CITY OF ALBUQUERQUE

**Re: Trapnell Orthodontics
Conceptual Grading and Drainage Plan
No Engineer's Date (J09D022)**

TRAPNELL ORTHODONTICS
CONCEPTUAL GRADING PLAN

CG-101

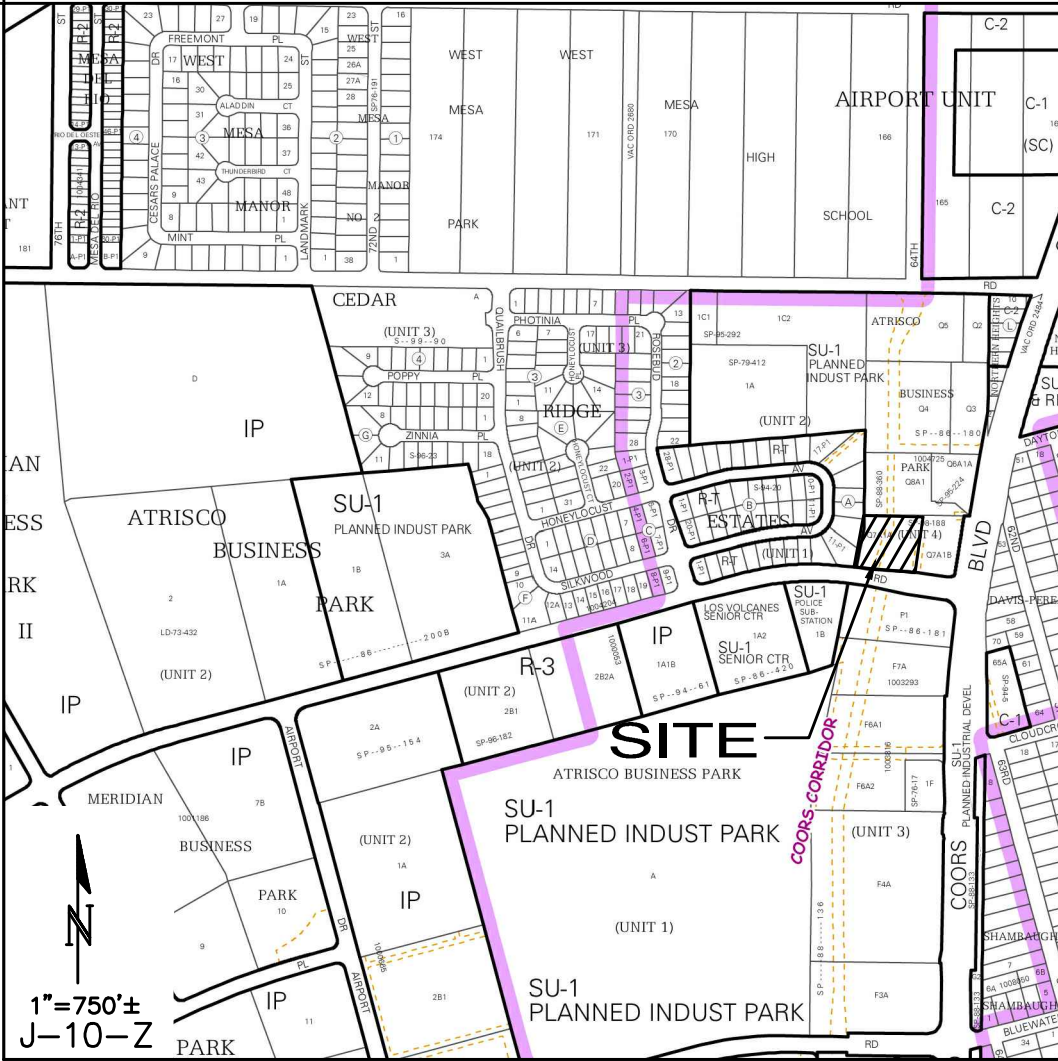
Based upon the information provided in your submittal received 9-23-14, the above referenced plan is approved for Site Plan for Building Permit Action by the DRB
